Access Compliance Report

# Public Rights-of-Way
(Curb Ramps)

Intersection ID: 5470	**Main Street: JOHN_KIRK_DR**	**Cross Street: GRADUATE_LN**	**Location: NW**
ADA ID: E8DA5C5C0E30	**Ramp Type: BlendTrans1**	**Initial Pass/Fail: Fail** **Overall Compliance: No**	**Severity Score: 10**

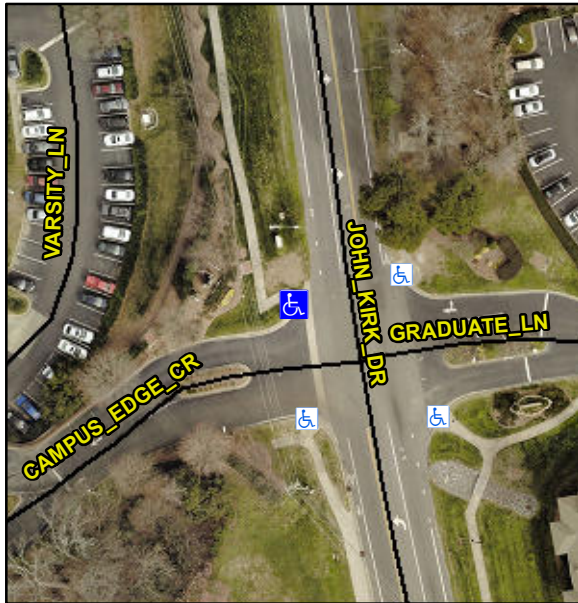
R304.5.1, R304.5.3

Compliance	Description	Data	Compliance	Description	Data
N/A	Ramp Length (in)	72.5	Yes	BlendTrans Slope (%)	4.2
No	Ramp Width (in)	37.0	No	BlendTrans XSlope (%)	4.0
N/A	Flare Type LT	N/A	N/A	Flare Type RT	N/A
N/A	Flare Slope LT (%)	N/A	N/A	Flare Slope RT (%)	N/A
N/A	Flare Traversable LT?	N/A	N/A	Flare Traversable RT?	N/A
N/A	Landing Length (in)	N/A	N/A	DWS Provided?	N/A
N/A	Landing Width (in)	N/A	N/A	DWS Contrast?	N/A
N/A	Landing Slope (%)	N/A	N/A	DWS Length (in)	N/A
N/A	Landing X Slope (%)	N/A	N/A	DWS Full Width?	N/A
N/A	Landing Curb? (Y/N)	N/A	N/A	DWS Offset (in)	N/A
N/A	Shared Landing?	N/A			
N/A	Gutter Ponding?	N/A	N/A	Gutter Slope (%)	N/A
N/A	Gutter Lip Ht (in)	N/A	N/A	Gutter X Slope (%)	N/A
N/A	Painted X Walk1?	No	N/A	Painted X Walk2?	No
	X Walk 1 Direction	To S		X Walk 2 Direction	To E
	X Walk 1 Width (in)	N/A		X Walk 2 Width (in)	N/A
	X Walk 1 Slope (%)	1.5		X Walk 2 Slope (%)	4.0
	X Walk 1 X Slope (%)	3.5		X Walk 2 X Slope (%)	2.7

Remove & Replace Curb Ramp With Two New Directional Ramps or Equivalent.
